Bulletin No. 2004-05

## 225 EFI Fourstroke Top Cowl

9399

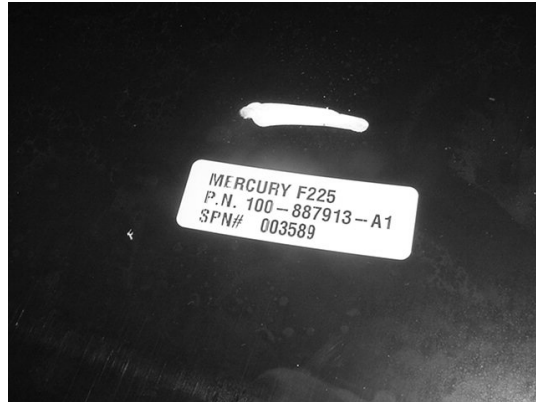
All units reworked at the factory will be marked by a white paint mark above the cowl serial tag illustrated below.
